PAL-2019-72711
Amendment No. 1 dated 18 June 2019

Amendment No.1 to Solicitation Documents

PAL-2019-72711: Construction of Wastewater Flow Measurement Systems in Qalqilya, Beit Jala and Ramallah
Issue Date: 28 May 2019
Closing date & time: 25 June 2019 8:00AM EDT

Galvanized Fence Protection
to be Installed Surrounding the PV Panels

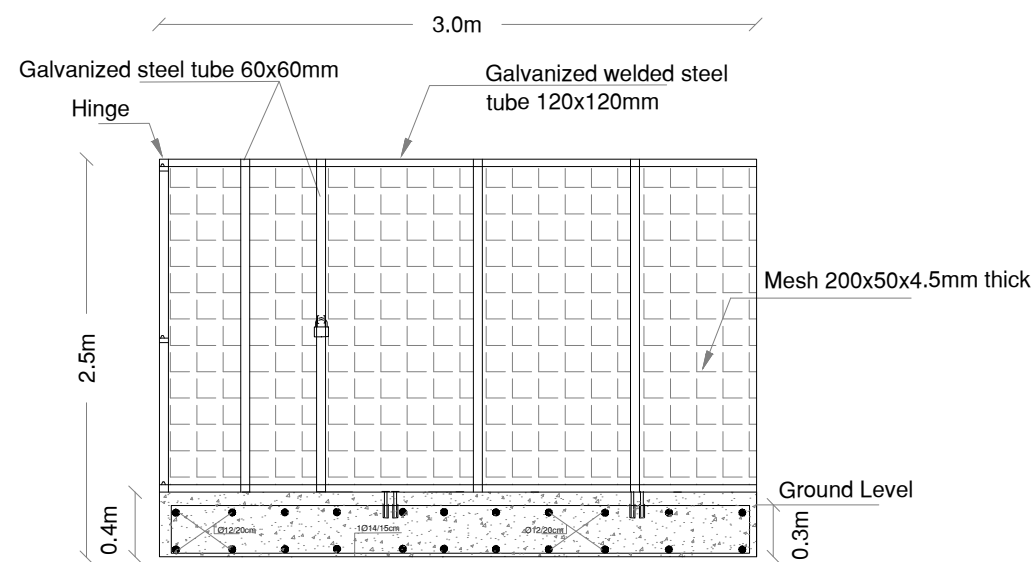
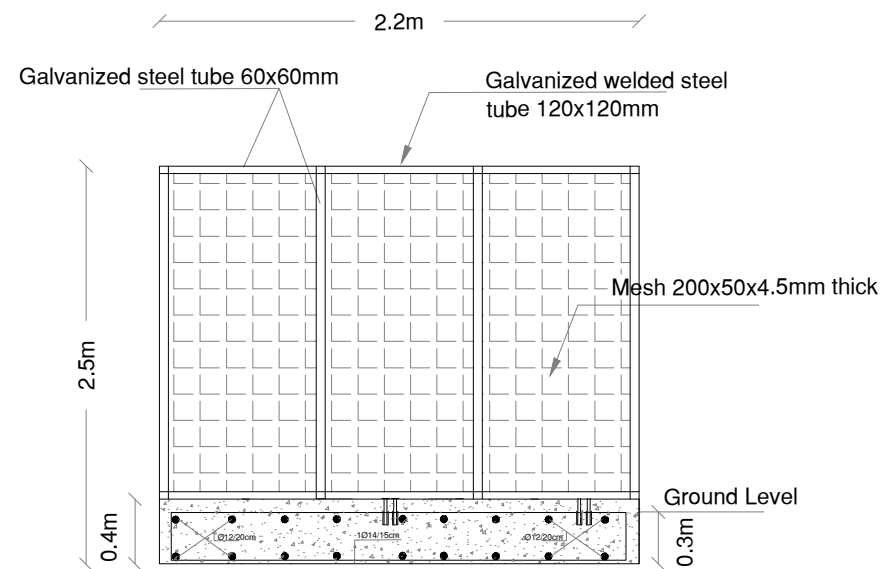
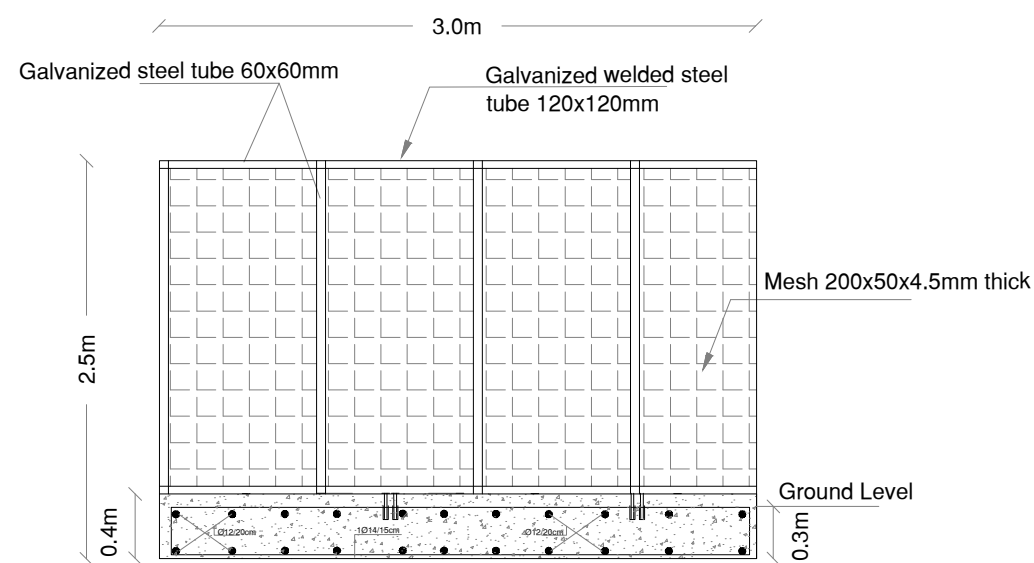
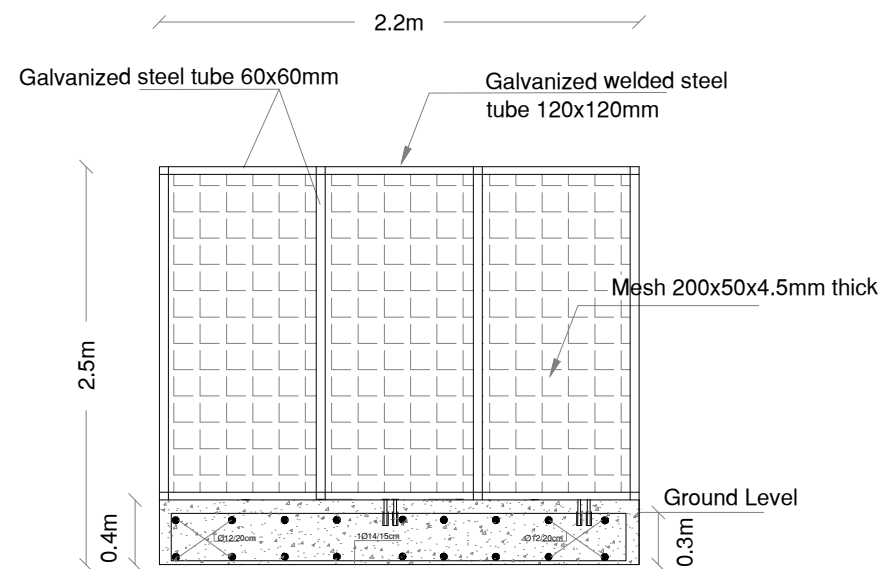
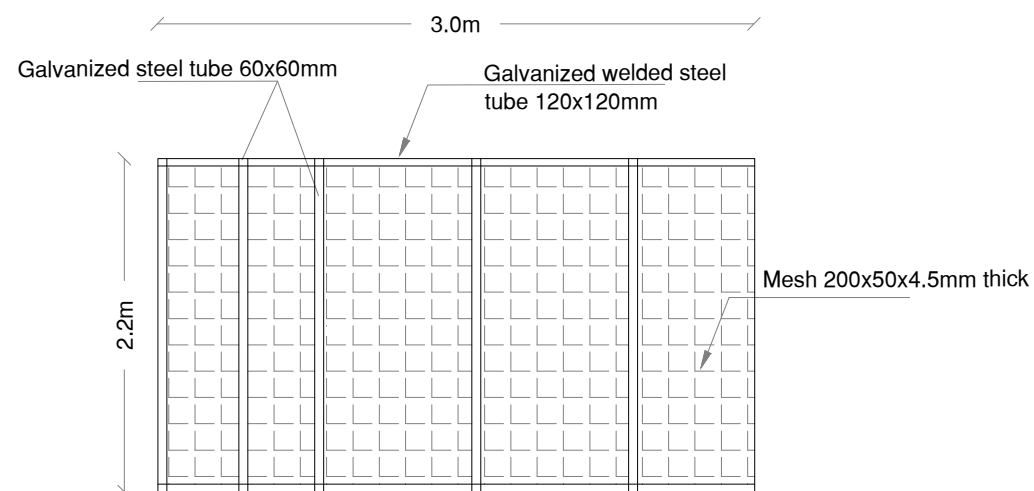
- (I) Item No 5.5 (PV Mounting Structure) in the Bill of Quantities (Bill #3 & Bill #4) has been modified as follow:

"Supply and install Module mounting structure from hot galvanized steel foundation profile suitable to the dimension of selected PV modules and PV numbers, the mounting provides a fixed inclination of the modules from 30 degree to 32 degree with vertical supports, plates, screws and casting, unit price also include excavation in any type of soil for reinforce concrete foundations B250 (3.0x2.2x0.4) m3 for the PV panels, the structure profile includes bracing and double hot galvanized angles for dividers. The mounting structure components are bonded together to guarantee potential equalization. The price includes supply and install a complete earth system (electrodes 15mm2, manhole with iron cover, earth joints, clamps and 25 mm2 flexible copper cable from the structure to the electrode, all necessary copper wires to connect arrays and modules in one loop for earthen. All precaution to have the resistance < 2Ω. Work also include supplying erection and anchoring Galvanized fence around the PV Panels including the ceiling and painting two coats according to the instructions of the supervisor engineer and the technical specifications. Unit rate also include Supplying, erection and anchoring gate of Galvanized fence for the area of the PV Panels. Price also includes removal of the unwanted relevant materials to dump site approved by the engineer. Exact location of the PV panels will be decided on site, all according to the drawings and engineer approval." Please see attached the technical details of the galvanized fence.

5.5	<p>PV Mounting structure: Supply and install Module mounting structure from hot galvanized steel foundation profile suitable to the dimension of selected PV modules and PV numbers, the mounting provides a fixed inclination of the modules from 30 degree to 32 degree with vertical supports, plates, screws and casting, unit price also include excavation in any type of soil for reinforce concrete foundations B250 (3.0x2.2x0.4) m3 for the PV panels, the structure profile includes bracing and double hot galvanized angles for dividers. The mounting structure components are bonded together to guarantee potential equalization. The price includes supply and install a complete earth system (electrodes 15mm2, manhole with iron cover, earth joints, clamps and 25 mm2 flexible copper cable from the structure to the electrode, all necessary copper wires to connect arrays and modules in one loop for earthen. All precaution to have the resistance < 2Ω. Work also include supplying erection and anchoring Galvanized fence around the PV Panels including the ceiling, and painting two coats according to the instructions of the supervisor engineer and the technical specifications. Unit rate also include Supplying, erection and anchoring gate of Galvanized fence for the area of the PV Panels. Price also includes removal of the unwanted relevant materials to dump site approved by the engineer. Exact location of the PV panels will be decided on site, all according to the drawings and engineer approval .</p>	L.S.	1

5.5	<p>PV Mounting structure:</p> <p>Supply and install Module mounting structure from hot galvanized steel foundation profile suitable to the dimension of selected PV modules and PV numbers, the mounting provides a fixed inclination of the modules from 30 degree to 32 degree with vertical supports, plates, screws and casting, unit price also include excavation in any type of soil for reinforce concrete foundations B250 (3.0x2.2x0.4) m3 for the PV panels, the structure profile includes bracing and double hot galvanized angles for dividers. The mounting structure components are bonded together to guarantee potential equalization. The price includes supply and install a complete earth system (electrodes 15mm2, manhole with iron cover, earth joints, clamps and 25 mm2 flexible copper cable from the structure to the electrode, all necessary copper wires to connect arrays and modules in one loop for earthen. All precaution to have the resistance < 2Ω. Work also include supplying erection and anchoring Galvanized fence around the PV Panels including the ceiling, and painting two coats according to the instructions of the supervisor engineer and the technical specifications. Unit rate also include Supplying, erection and anchoring gate of Galvanized fence for the area of the PV Panels. Price also includes removal of the unwanted relevant materials to dump site approved by the engineer. Exact location of the PV panels will be decided on site, all according to the drawings and engineer approval</p>	L.s	1
